Project	IEEE 802.16 Broadband Wireless Access Working Group < http://ieee802.org/16 >	
Title	Extension of collaborative spatial multiplexing in OFDMA	
Date Submitted	2005-01-20	
Source(s)	Bin-Chul Ihm, Yongseok Jin, Jinyoung Chun, Kyuhyuk Chung	Voice: 82-31-450-7187 Fax: 82-31-450-7912
	LG Electronics, Inc. 533, Hogue-1dong, Dongan-gu, Anyang-shi, Kyongki-do, Korea	[mailto: {bcihm, jayjay, jychun03, kyuhuk} @lge.com]
	Ran Yaniv, Tal Kaitz	[mailto: {ran.yaniv, tal.kaitz} @alvarion.com]
	Alvarion Ltd.	
Re:	This is a response to a Call for Comments on IEEE P802.16e-D5a	
Abstract	The collaborative spatial multiplexing can be applied to the case in OFDMA.	
Purpose	This document is submitted for review by 802.16e Working Group members. <u>Pink line indicates the revised text.</u>	
Notice	This document has been prepared to assist IEEE 802.16. It is offered as a basis for discussion and is not binding on the contributing individual(s) or organization(s). The material in this document is subject to change in form and content after further study. The contributor(s) reserve(s) the right to add, amend or withdraw material contained herein.

Extension of Collaborative Spatial Multiplexing in OF

Figure 2. The case of two SSs with dual transmit antennas

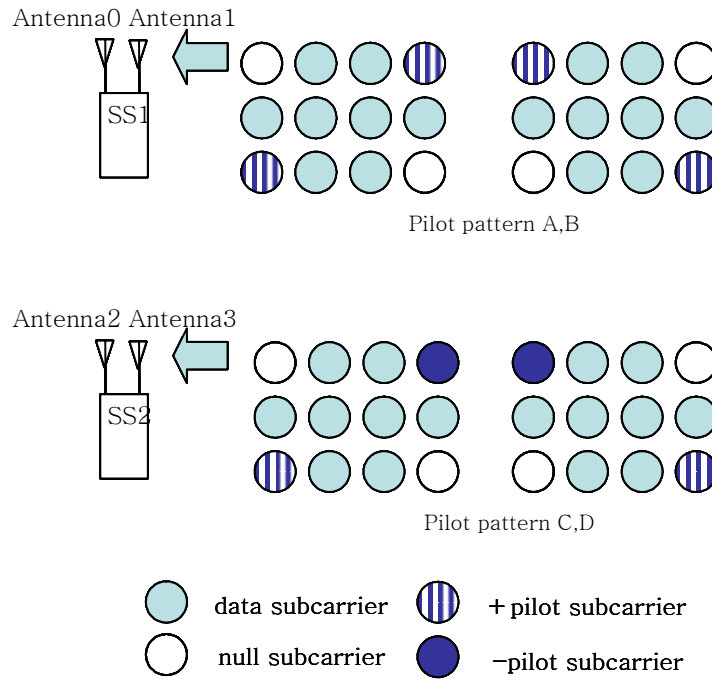
The second example of the aforementioned collaborative SM examples requires four pilot patterns to distinguish the channels from each antenna of MSSs. For the purpose of realizing the above configurations, more pilot patterns are needed to support the various collaborative SM modes. Therefore, we propose to add new pilot pattern C, D to current pilot pattern A, B as shown in Figure 2.

[Insert Figure 249a after Figure 249 as follows:]

[Figure 249a – Pilot Patterns in UL PUSC tile](#)

Two single transmit antenna SS's can perform collaborative spatial multiplexing onto the same subchannel. In this case, the one SS should use the uplink tile with pattern-A and the other SS should use the uplink tile with pattern-B. [Also, two dual transmit antenna SS's can perform collaborative spatial multiplexing onto the same subchannel. In this case, the one SS should use the uplink tile with the pilot pattern A, B and the other SS should use the uplink tile with the pilot pattern-C, D through MIMO UL Basic IE. Pilot patterns are illustrated in the Figure 249 and 249a.](#)
